Response to NRC ltr dtd 12/06/77...
Furnishing responses to the "Questionnaire for Fracture Toughness Properties of Older Reactor Vessels", consisting of:

SUSQUEHANNA SES
PRESSURE VESSEL FRACTURE TOUGHNESS PROPERTIES
ER 100450 FILE 840-2
PLA-237

DOCKET NOS. 50-387
AND 50-388

Ref: CBIN DWG: P6-205-H0-957
DWG No E-1 Rev 4
Contract # 68 3331

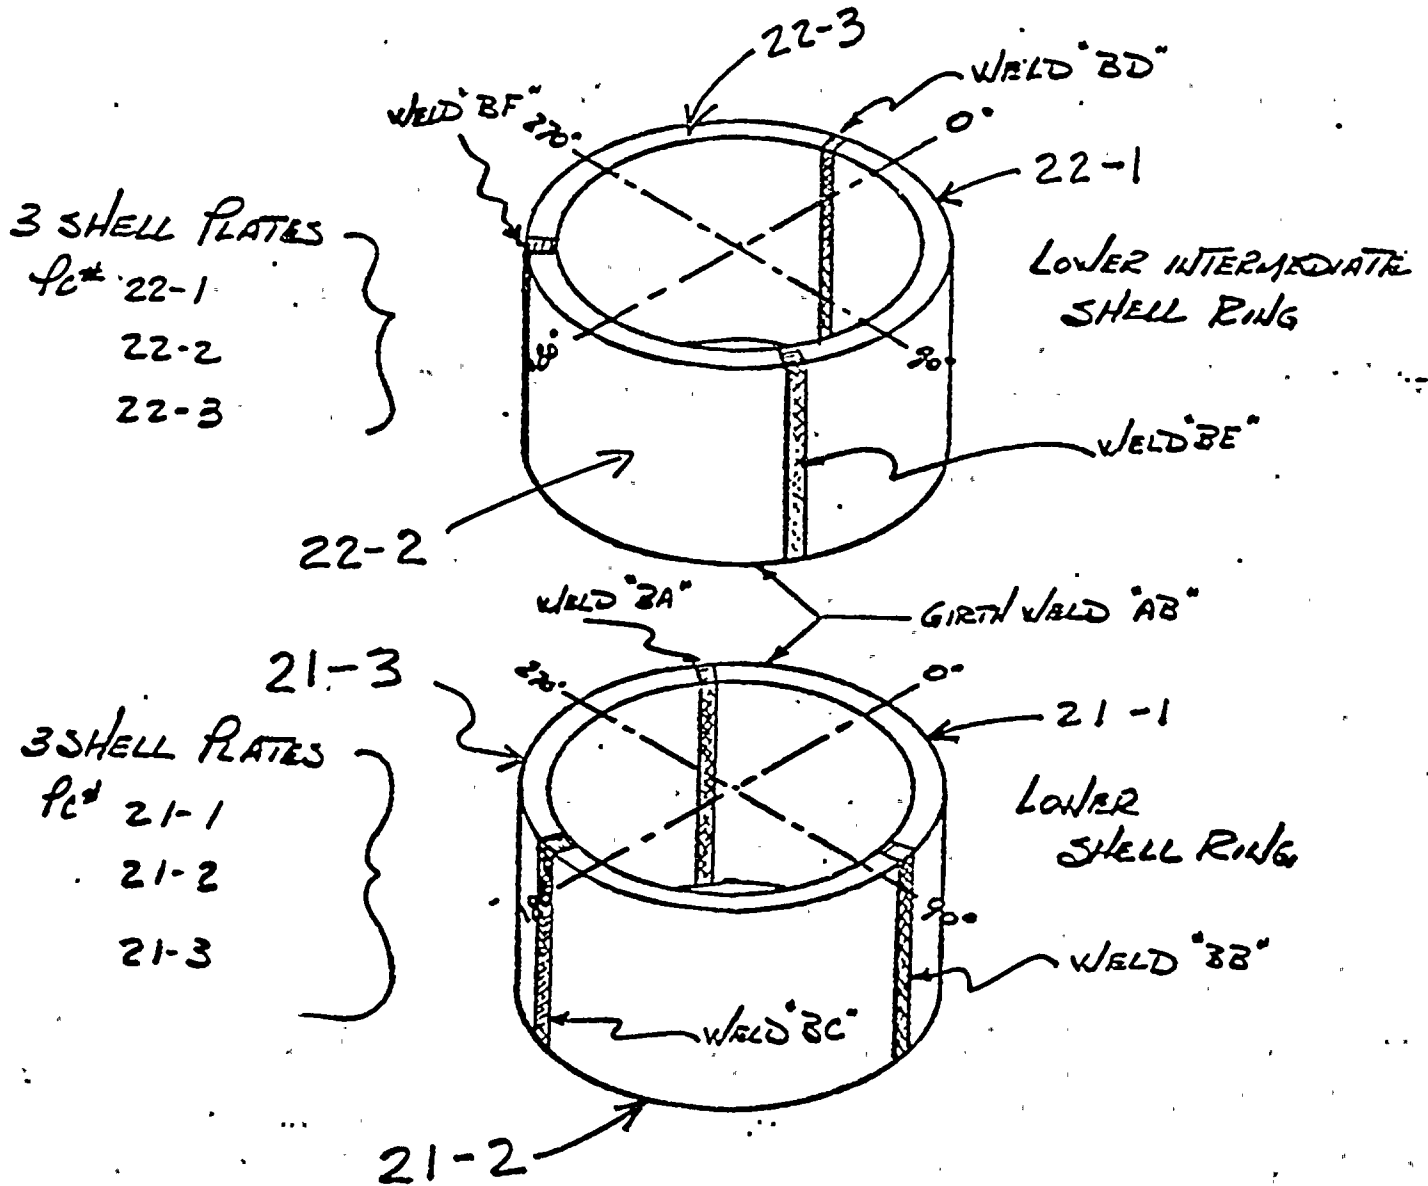
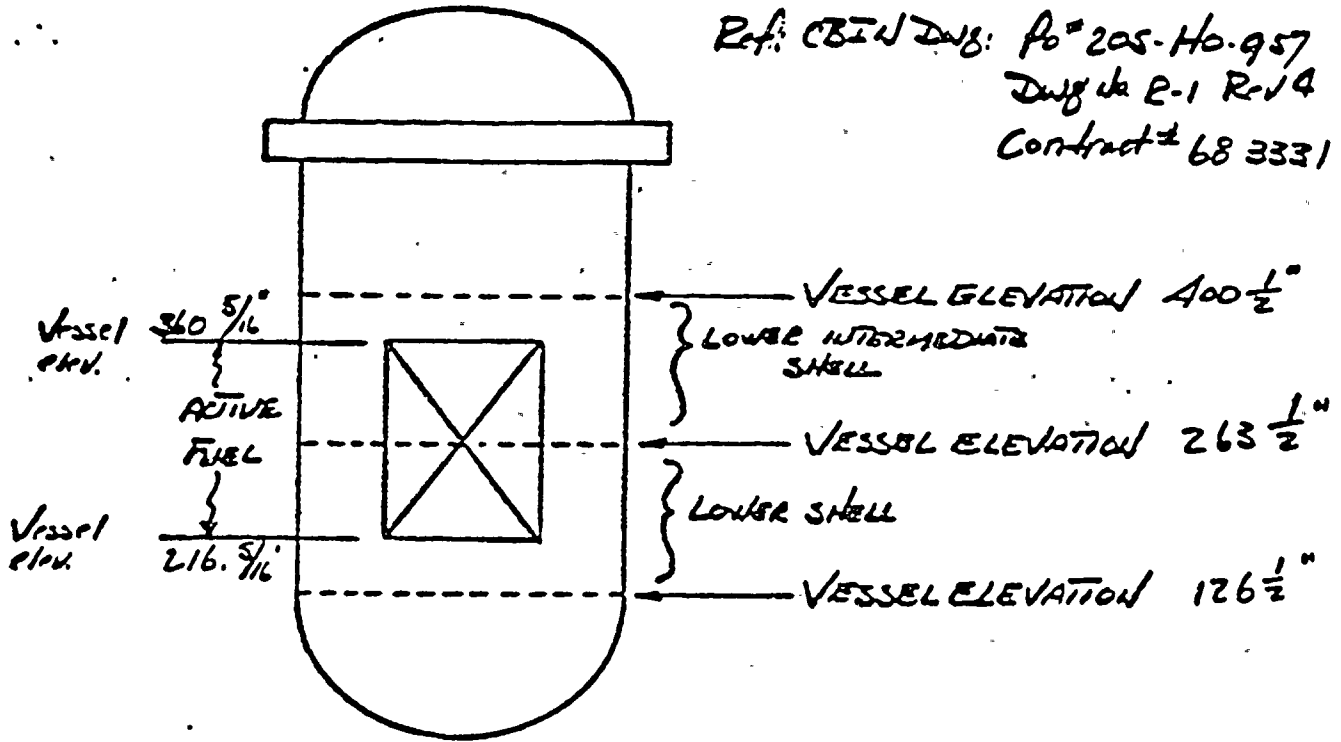
- 121.2 Identify each material (plate, and/or forging and weld metal) in the beltline region (as defined by paragraph II. H, Appendix G, 10CFR Part 50) and provide a sketch showing the location of these materials in the reactor vessel. Provide the following information for each material:
- (1) Chemical analyses; particularly those elements known to affect irradiation sensitivity and degrade the upper shelf fracture energy (Cu, P, and S).
 - (2) Unirradiated fracture toughness properties (T_{NDT} , RT_{NDT} and upper shelf fracture energy) as required by Appendix G, 10CFR Part 50, identifying the limiting material in the reactor vessel beltline region.
 - (3) Estimate the maximum anticipated change in RT_{NDT} and upper shelf fracture energy as a function of the EOL fluence at the inner wall for the materials in the beltline region of the reactor vessel.

- 121.2 Materials in the reactor pressure vessel beltline region are identified as listed below and as shown on the attached sketch:

A. Lower Shell Course (CBIN Dwg R-1, Rev. 4, Contract No. 683331)

<u>PC #</u>	<u>ID #</u>	<u>MELT #</u>	<u>SLAB #</u>
21	1	CB5083	1
21	2	C0770	2
21	3	C0814	2

LOWER INTERMEDIATE SHELL
(3 PLATES)

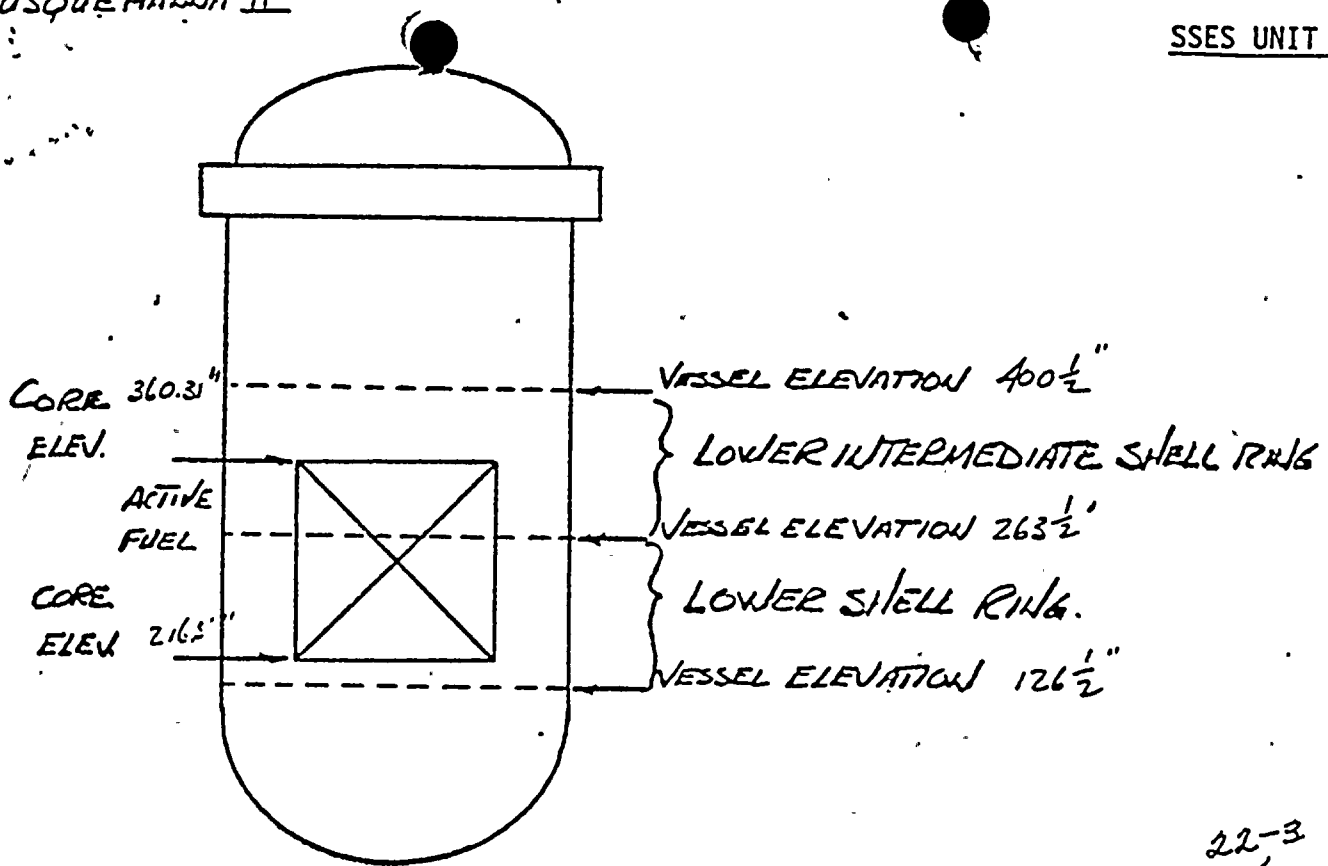
121.2 Identify each material (plate, and/or forging and weld metal) in the beltline region (as defined by paragraph II.11, Appendix G, 10CFR Part 50) and provide a sketch showing the location of these materials in the reactor vessel. Provide the following information for each material:

121.2 Materials in the reactor pressure vessel beltline region are identified as listed below and as shown on the attached sketch:

PC# 22-A SHELL ASSY
PLATES

PC# 21-A - SHELL ASSY
PLATES
